March 5, 2009

Subject: UniStar Nuclear Energy, NRC Docket No. 52-016  
Calvert Cliffs Nuclear Power Plant, Unit 3  
Environmental RAIs No. 1001 through 1011

The purpose of this letter is to respond to the requests for additional information (RAIs) identified in the NRC letter to UniStar dated February 3, 2009 (Reference 1). The RAIs address figures needed to publish the environmental impact statement (EIS) and information necessary for completion of regulatory reviews.

**FIGURE 2.2-1** Rev. 0  
 LAND USE ON THE CCNPP SITE  
 CCNPP UNIT 3 ER

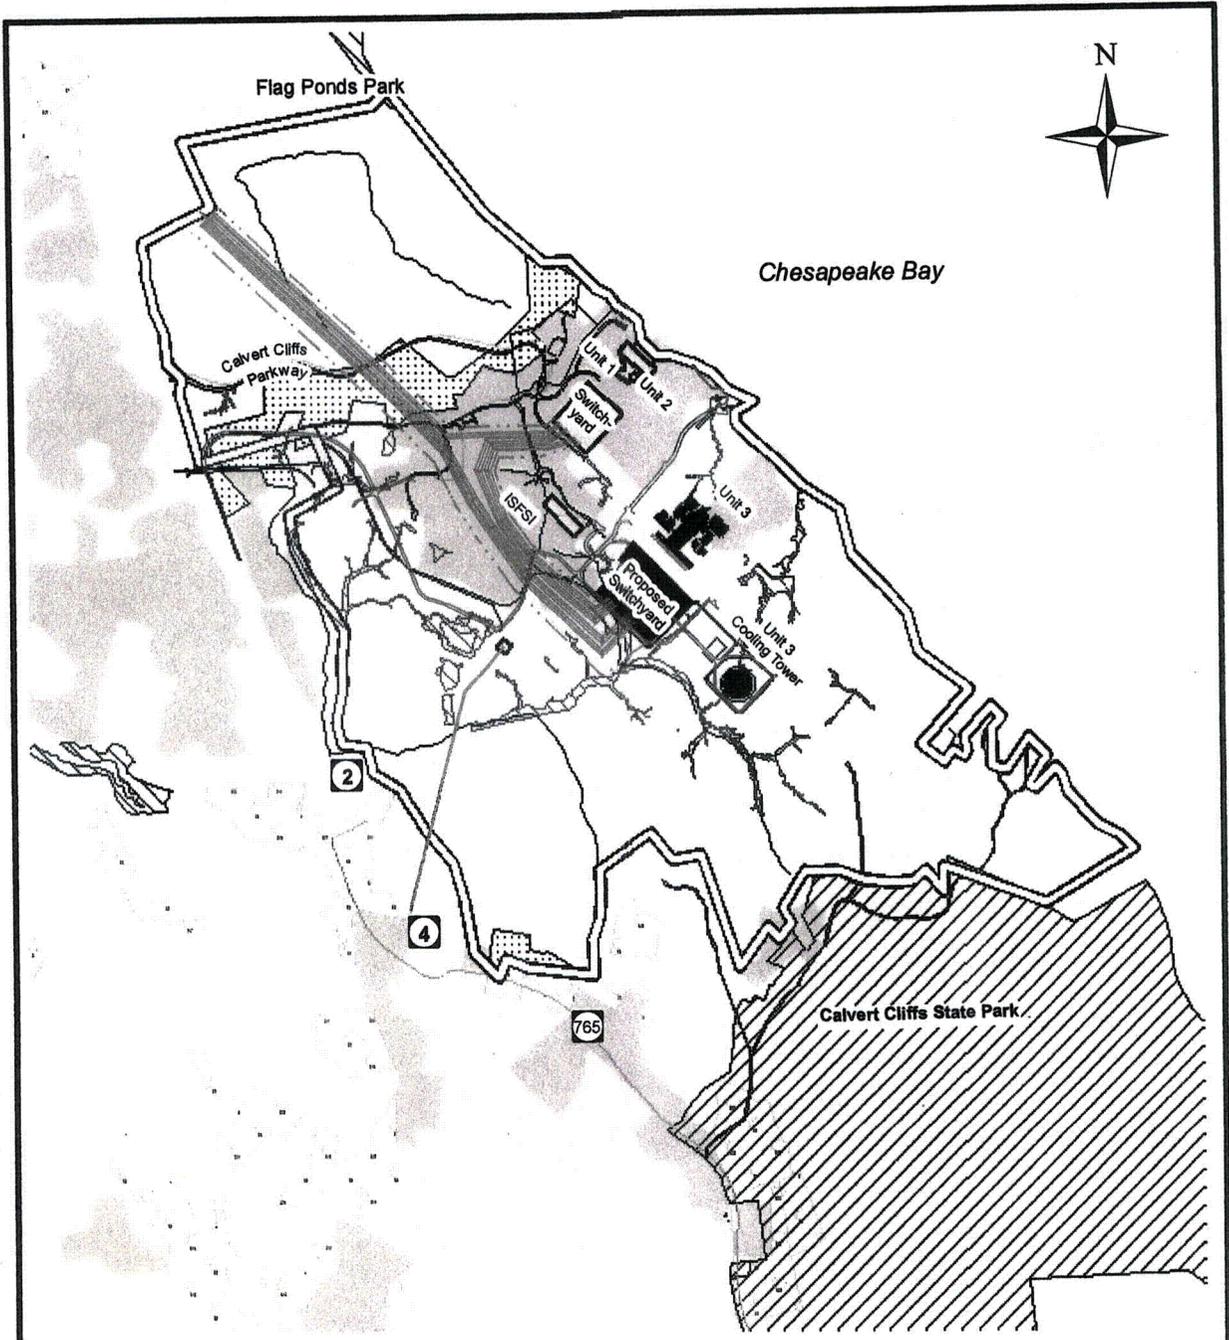
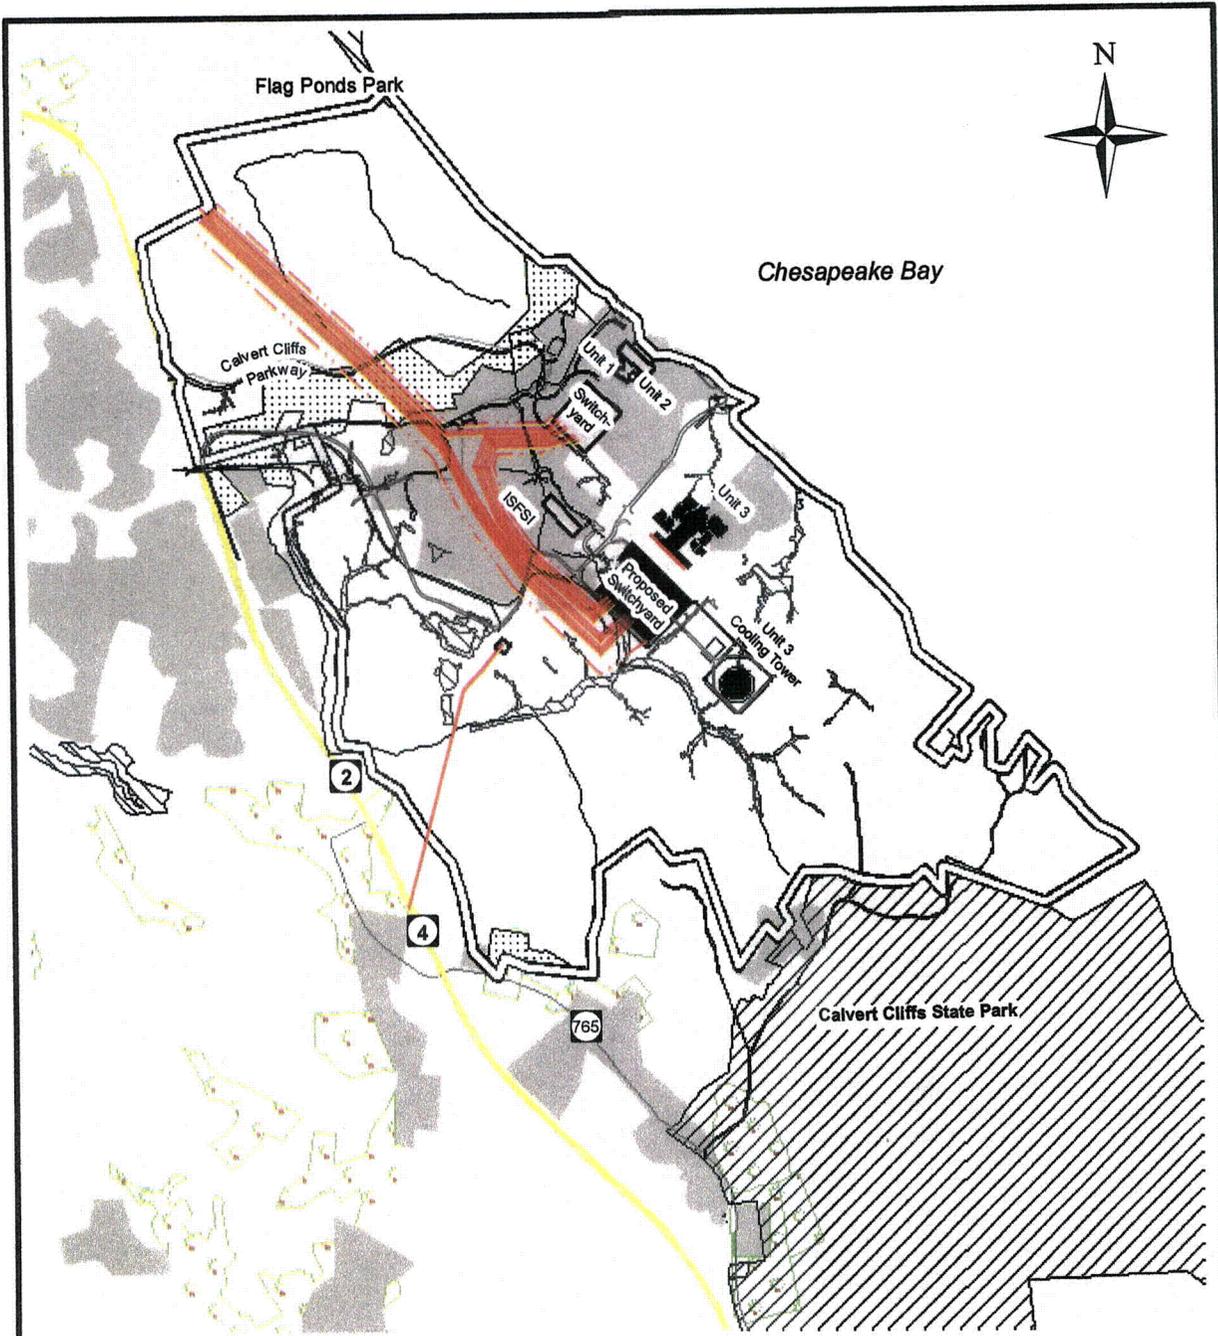
Provide a revised ER Fig 2.2-1 that specifically indicates the transmission line circuit to the proposed switchyard and onsite wetlands. The staff notes that agriculture is no longer practiced onsite but that the area previously used for this purpose is still shown in figure 2.2-1. The figure should be revised to either (1) remove the marking from the areas currently marked as agricultural, or (2) change the legend to state the areas show historic use of agriculture.

UniStar has prepared a figure for use in the printed version of the EIS. See attached black and white figure.

The CCNPP Unit 3 Environmental Report will be updated to incorporate the response to this RAI question in a future COLA revision, as shown in the attached color figure.

**ESRP 2.4.1 – 1**

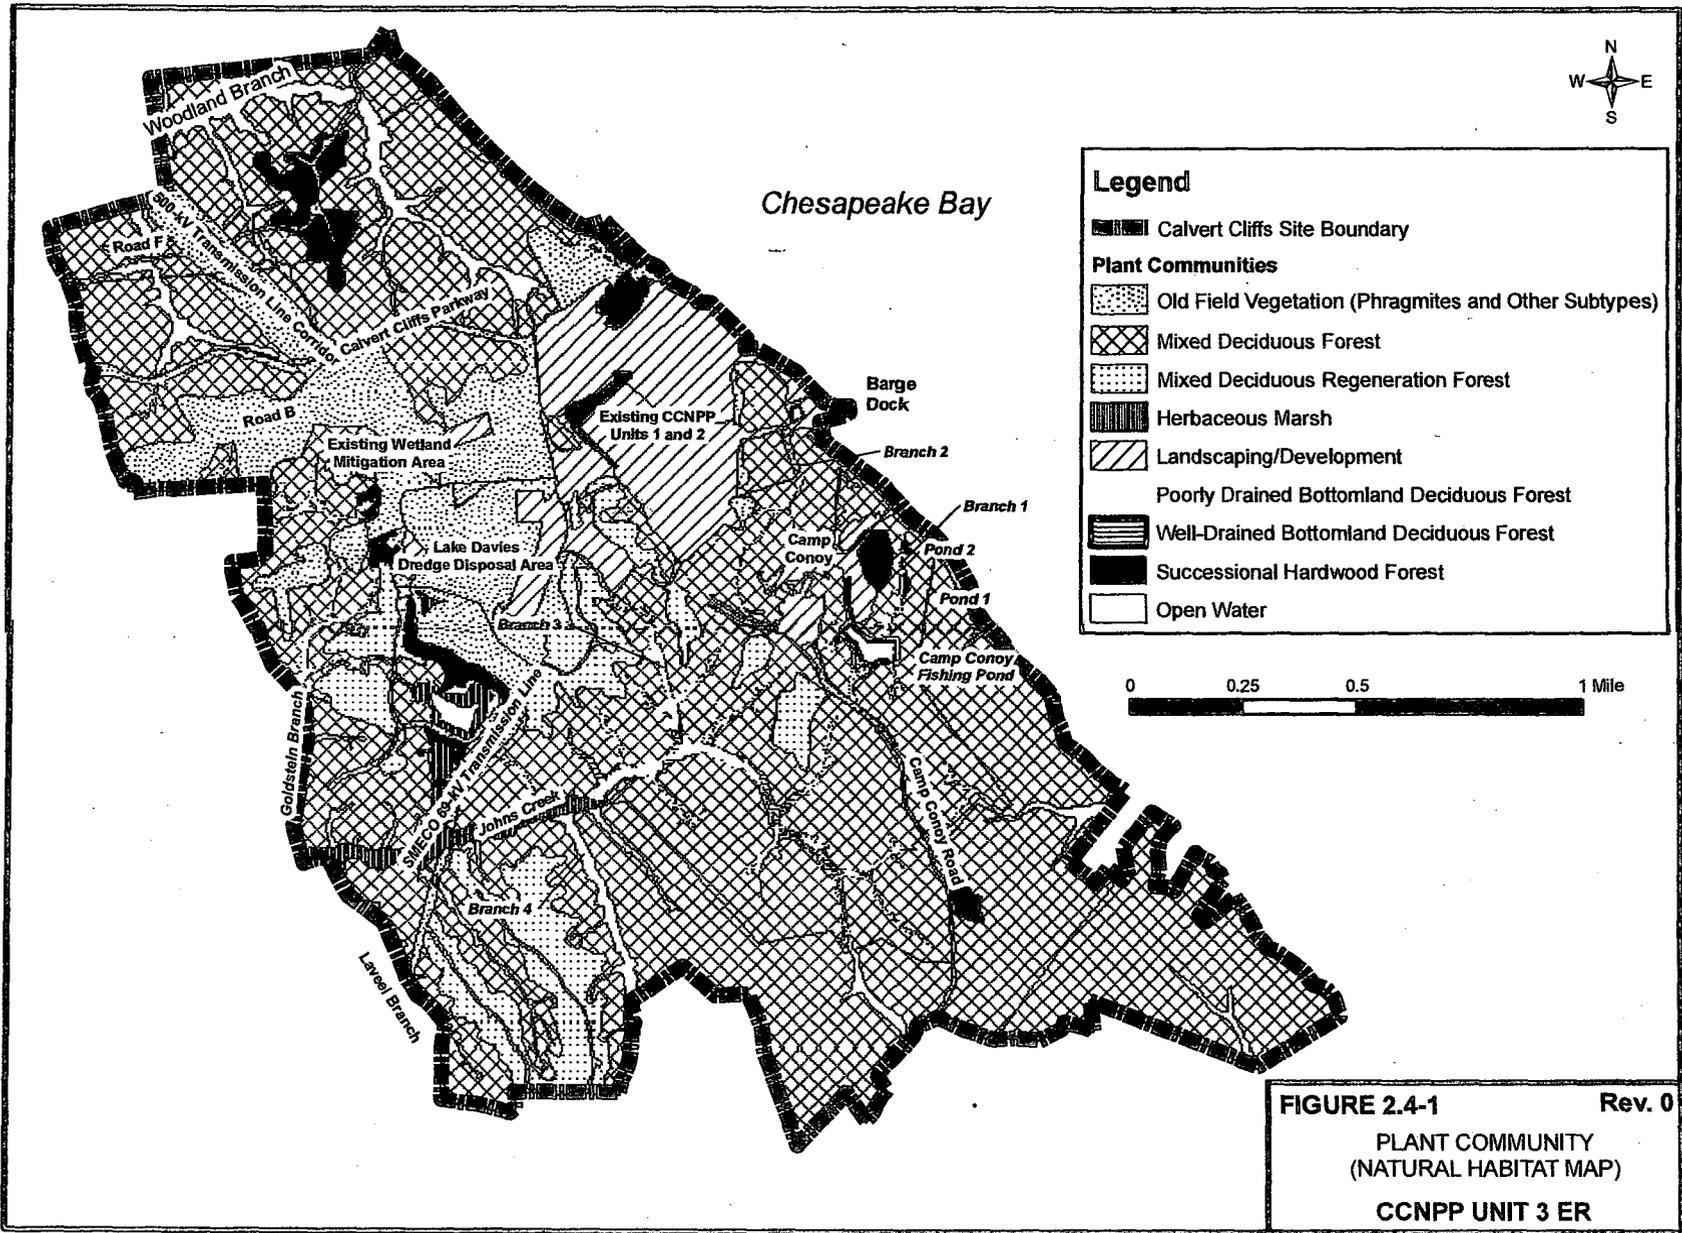
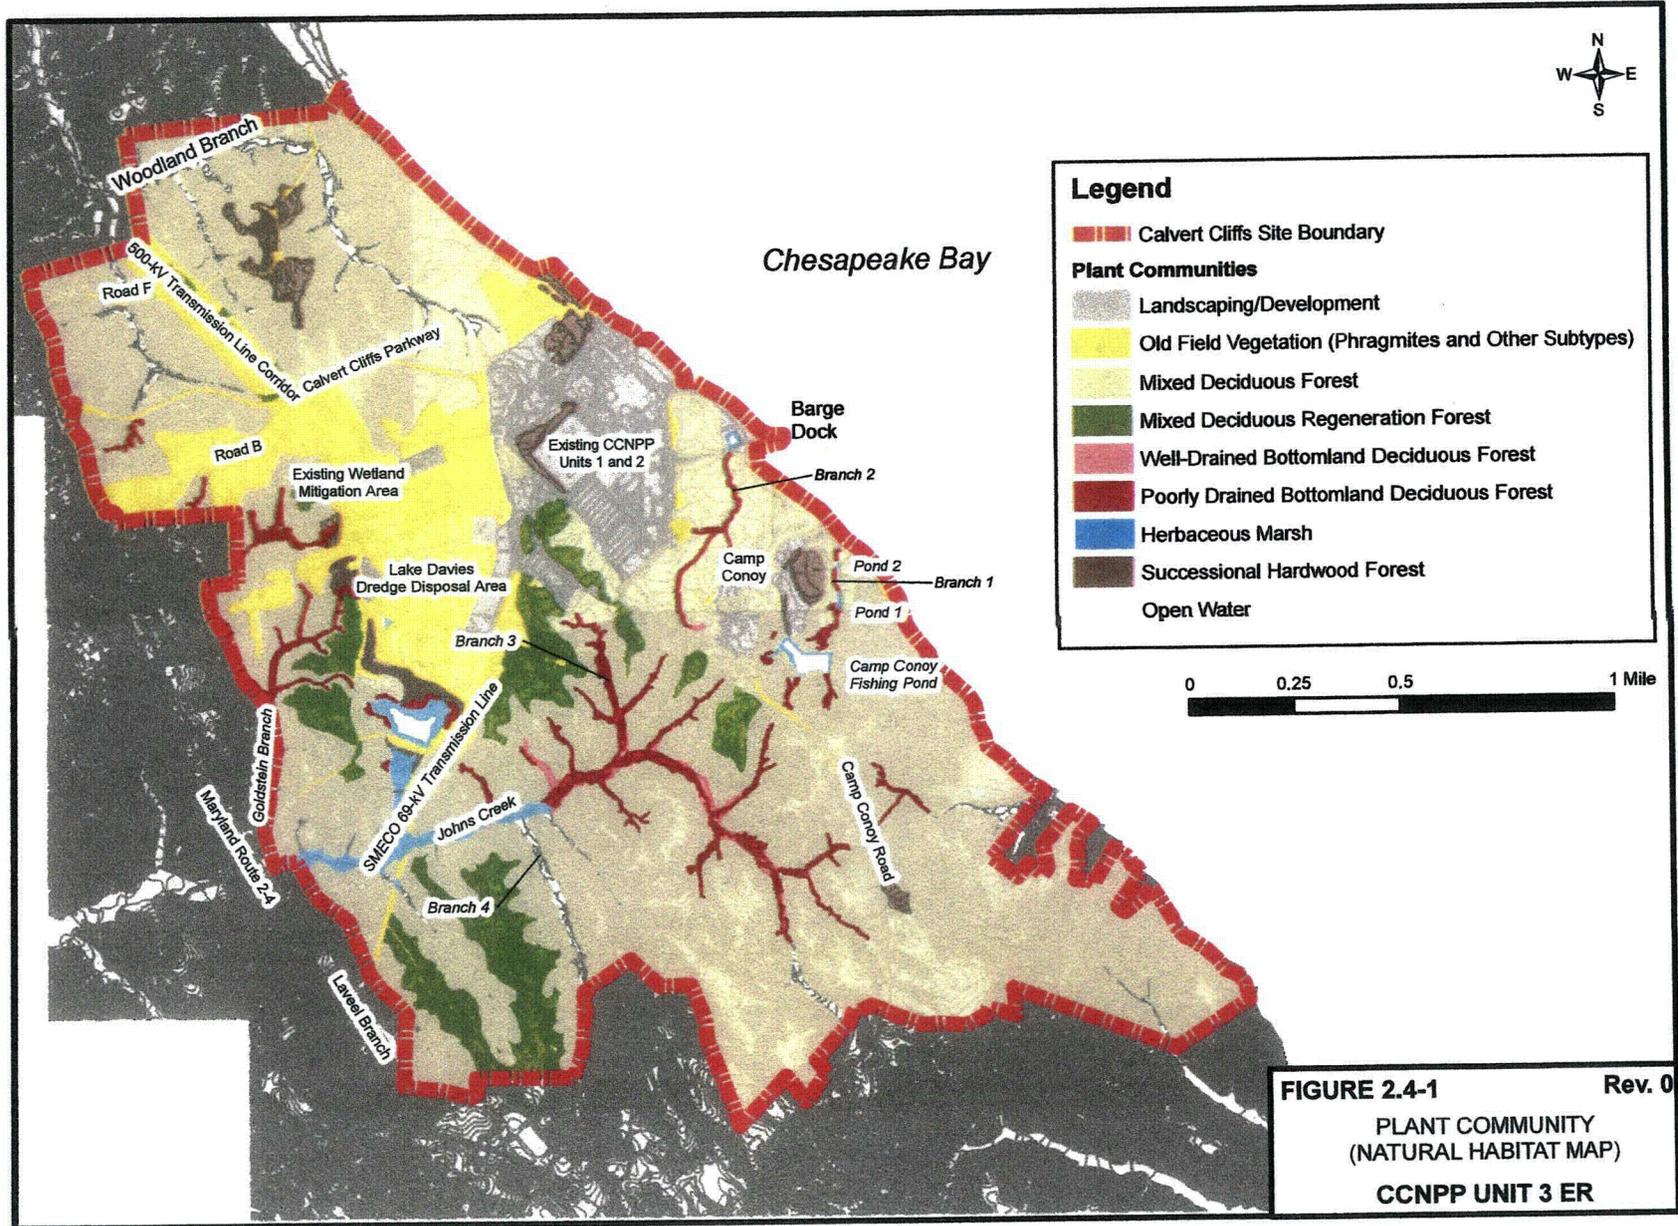
Provide a revised version of ER Fig 2.4-1 with a legible legend depicting only the following attributes: Calvert Cliffs site boundary, Chesapeake Bay label, Plant communities: Mixed Deciduous Forest, Old Field (Phragmites and Other subtypes combined), Landscaping/Development, Mixed Deciduous Regeneration Forest, Well-drained Bottomland Deciduous Forest, Poorly Drained Bottomland Deciduous Forest, Herbaceous Marsh, Successional Hardwood Forest. In addition to the aquatic resources already labeled,

UniStar has prepared a figure for use in the printed version of the EIS. See attached black and white figure.

The CCNPP Unit 3 Environmental Report will be updated to incorporate the response to this RAI question in a future COLA revision, as shown in the attached color figure.
